Active Transport Response

Information Request Response

To	Kwikbridge Pty Ltd	Date	4 December 2023
Prepared by	Giada Rendina, Modus Graduate Traffic Engineer	Approved by	Tetteh Anang, Modus Senior Traffic Engineer (RPEQ 28656)
Location	81 Savage Street, Cooktown		
Subject	Proposed Shopping Centre Development - Traffic Engineering IR Response		
Status	Final	Attachments	Appendix A: Council Information Request Appendix B: Proposed Development Plans Appendix C: Existing Active Transport Network Appendix D: Pedestrian Crossing Facility Results Appendix E: Proposed Active Transport Network

3 SITE SECTION 03
DA03 1:100

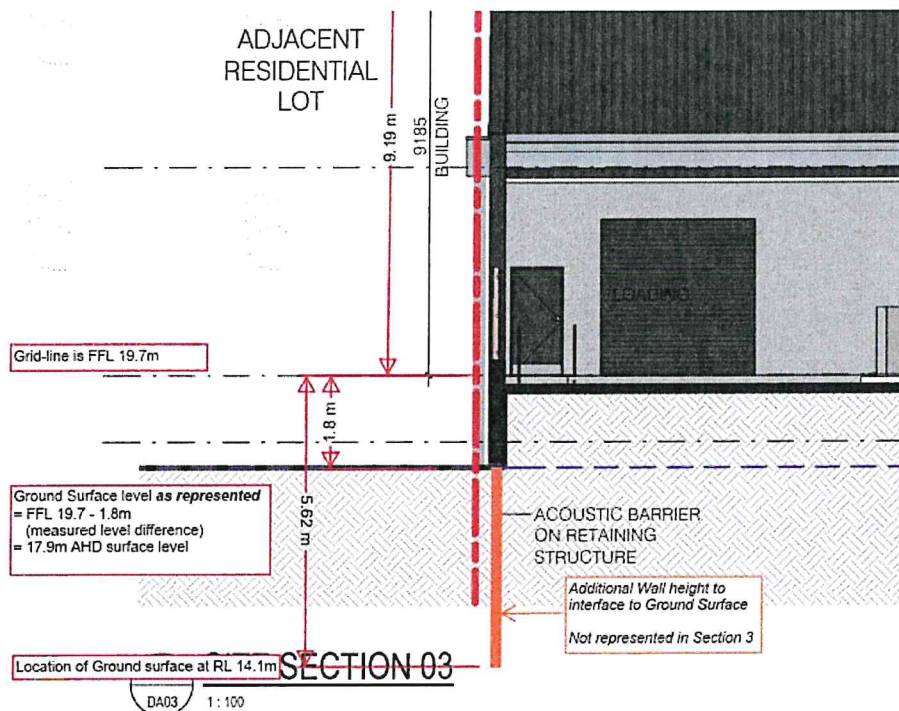
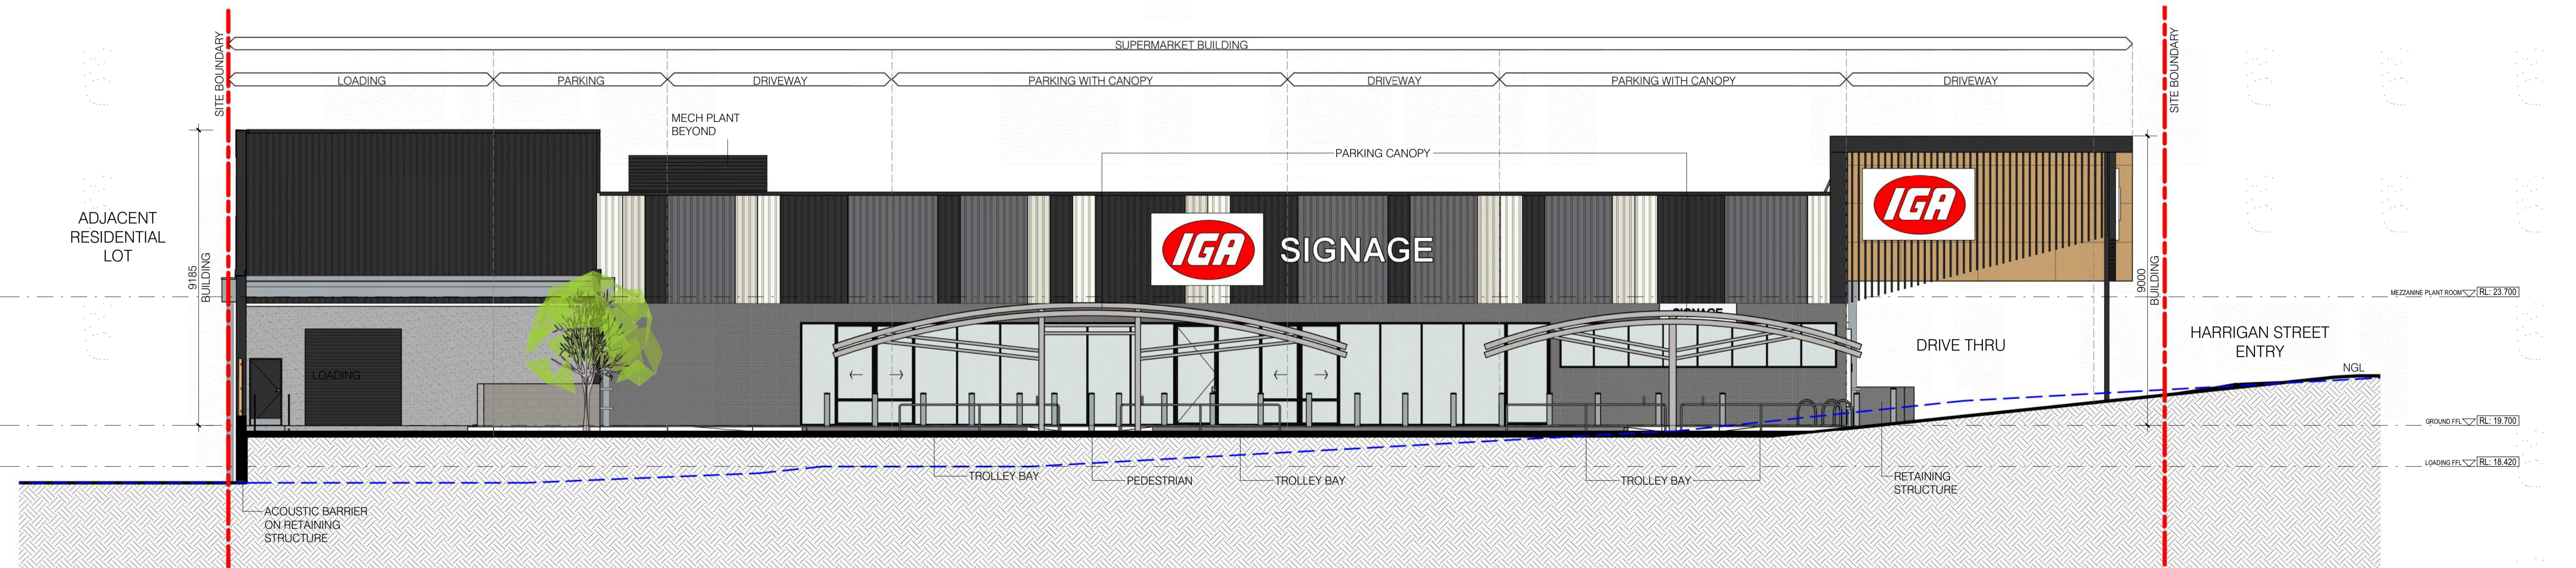
(a) Example A, Western Boundary on Section 3, Drawing DA08.

Section 3 on Drawing DA08 does not appear to represent the natural surface and resulting level difference correctly (refer extract below).

The existing surface is represented as being only 1.8m below the FFL line of 19.7m. That is, the natural surface level at the Lot boundary on drawing DA08 Section 3 is measured as approximately RL17.9m.

However, the spot level shown on drawing DA03 near Section 3 is nominated as RL14.1. This represents a difference of approximately 2.8m between the represented surface and the actual surface.

- 13. Provide revised drawings that address the apparent discrepancies with the existing ground surface level shown on the elevations and sections. The updated detail must also correct the building height line shown and ensure that the plans accurately represent the height above the existing ground level.**

4 WEST ELEVATION
DA03 1:100

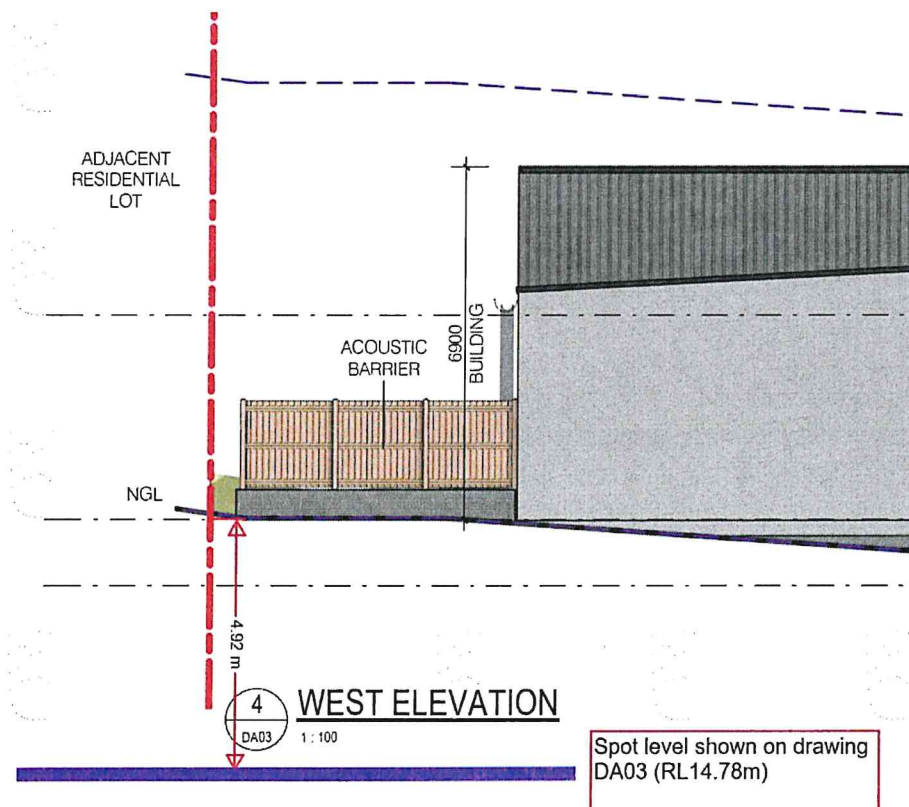
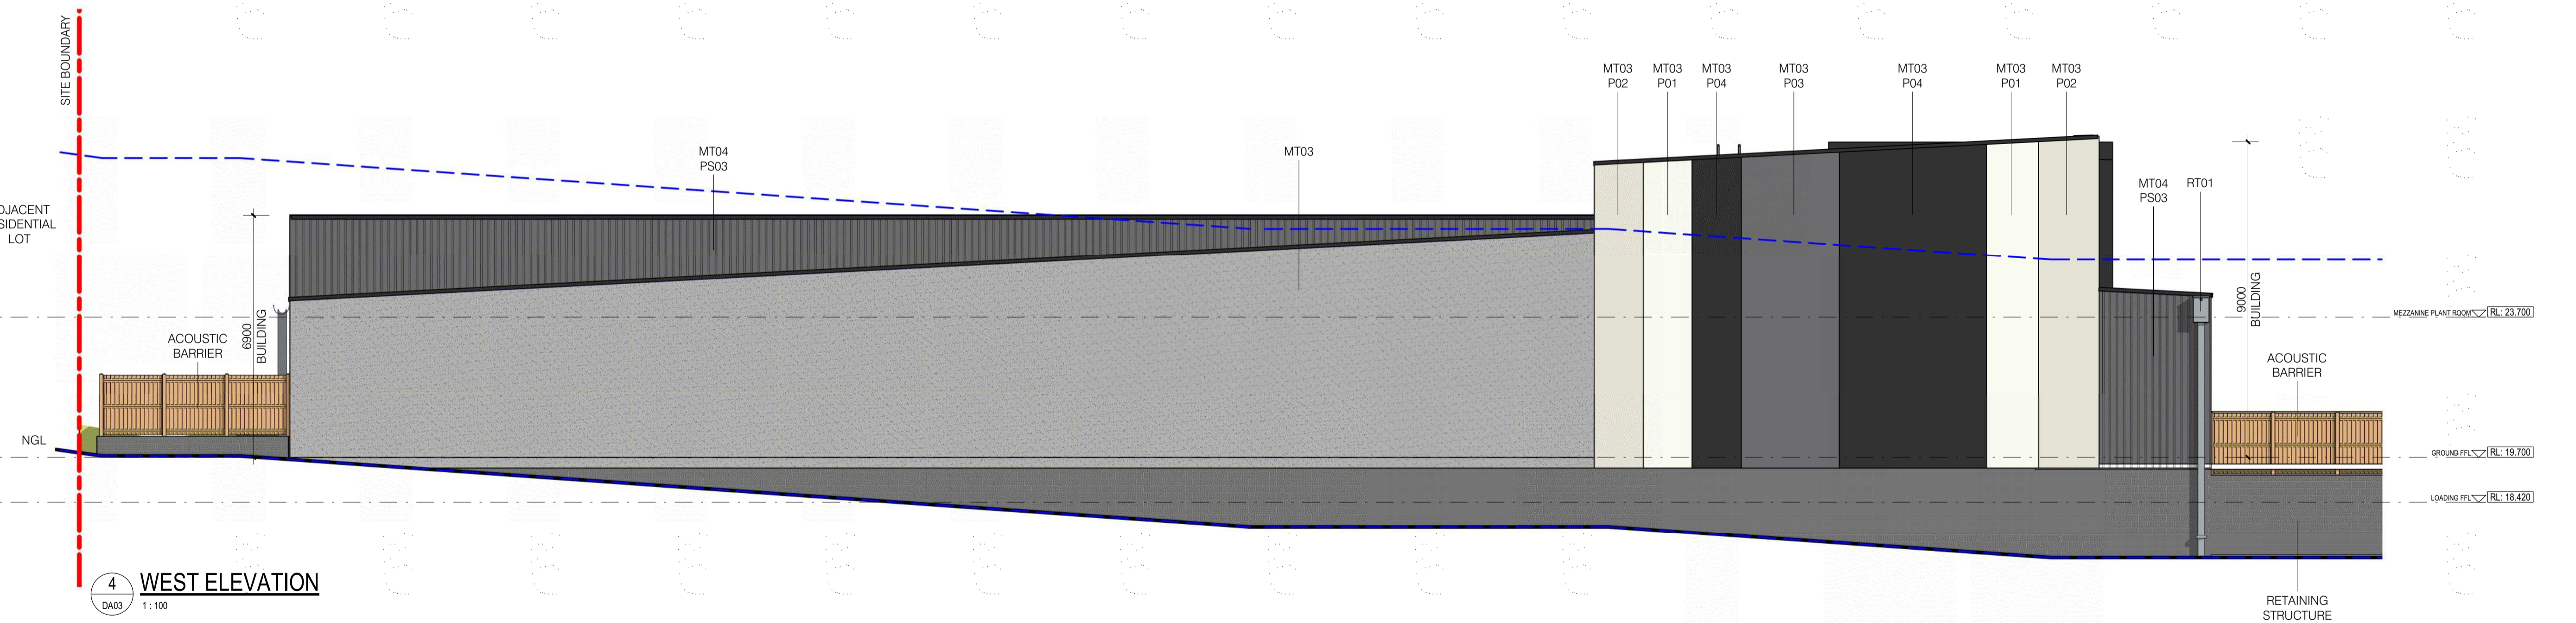
The spot level shown on drawing DA03 at the corner of northern and western Lot boundaries is RL14.78. This level has been verified against the site contours in the Bulk Earthworks design.

However, there is an inconsistency between this level and the existing surface level (and profile) represented in the West Elevation shown on drawing DA07.

The existing surface level at the Lot boundary on drawing DA07 West Elevation section is shown to be coincident with or above the level of the FFL for the building, RL19.7m.

Given the building has minimal setback to the western boundary, the west elevation should reflect the levels along the western boundary. The spot level of RL14.78, verified from the Bulk Earthworks design, represents a difference of almost 5m from the existing ground level shown.

It appears that the long sections on drawing DA08 and DA07 do not present the natural surfaces at the western Lot boundary and the interface between design levels and natural surface levels correctly.

project	drawing no.	issue
2022-072	DA03	TP3
AS	designed	checked
indicated	PCH	Checker

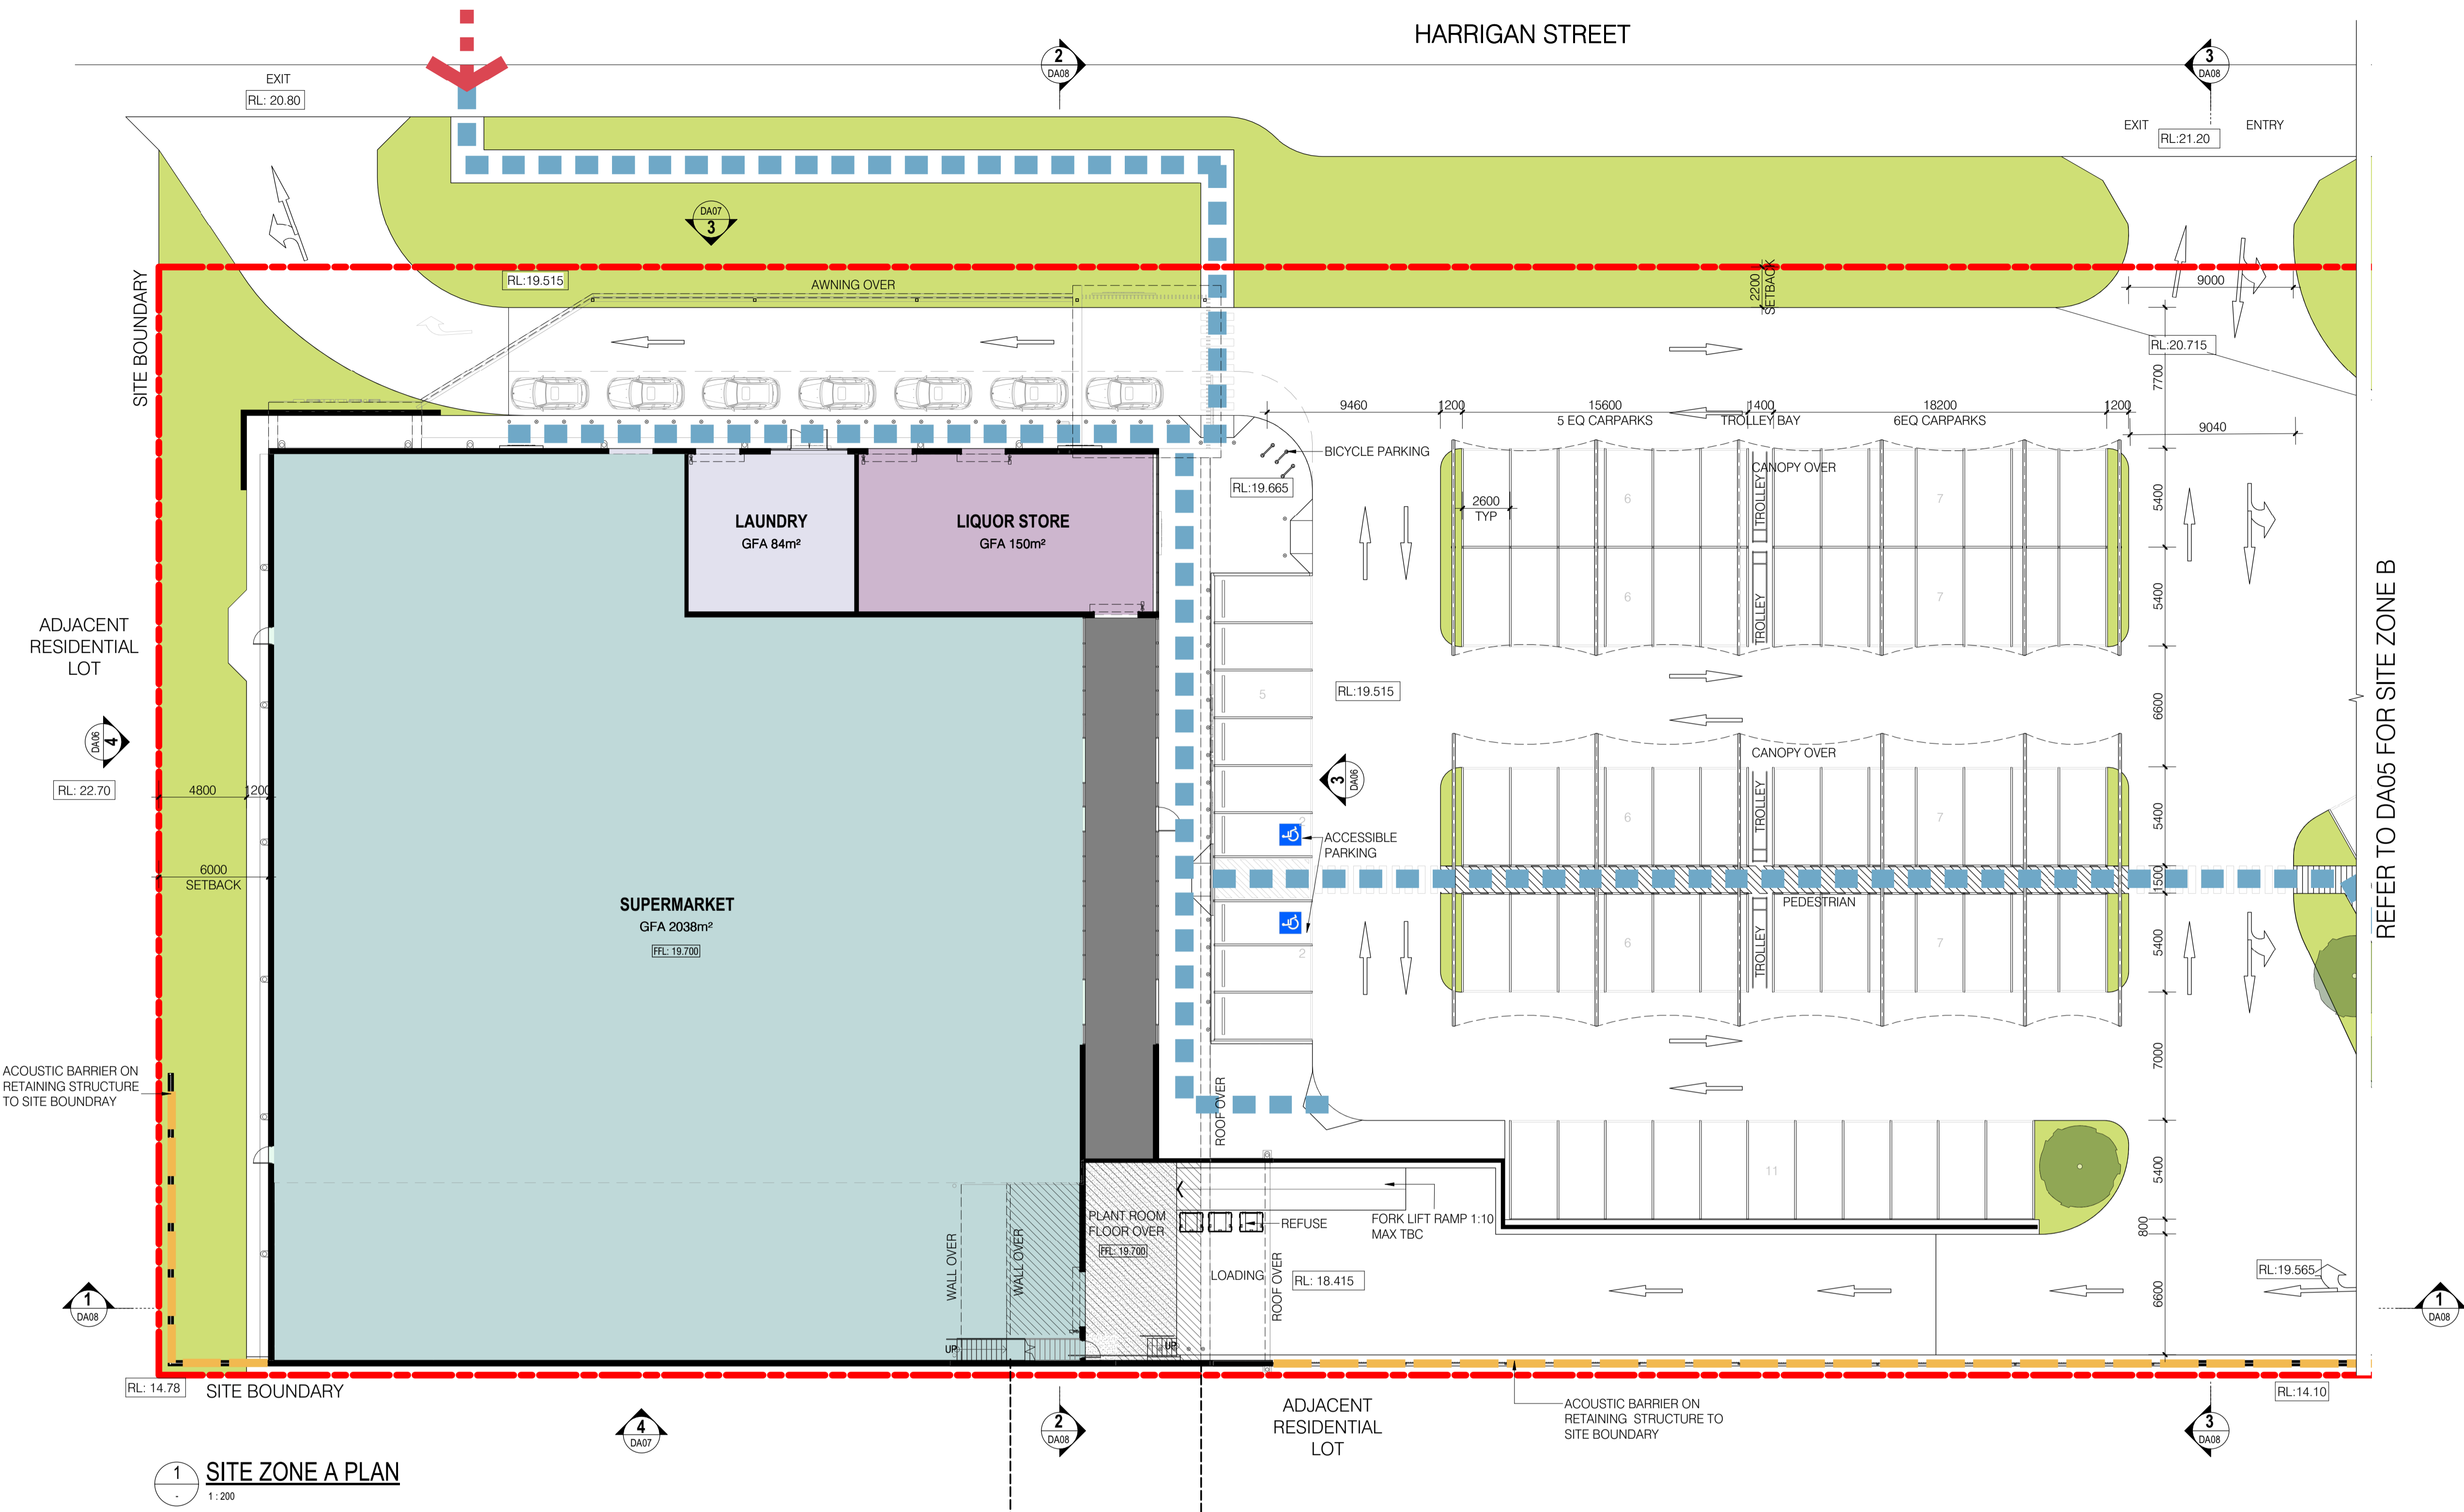
Drawing DA03 shows pedestrian access to Harrigan Street however no further information regarding pedestrian access is provided.

Drawing DA03 shows pedestrian access to Harrigan Street however no further information regarding pedestrian access is provided.

Modus has reviewed the existing active transport facilities within a 700m radius from the proposed development site to identify inconsistencies in the provision of transport routes for pedestrians, cyclists, and mobility scooter users. The existing active transport facilities are provided at **Appendix C**.

In line with Council's request, the existing active transport network is required to be upgraded to ensure that the proposed development provides sufficient connectivity to the Cooktown town centre, as well as the surrounding residential catchment. Therefore, Modus has proposed upgrades to the existing active transport infrastructure in accordance with the following standards:
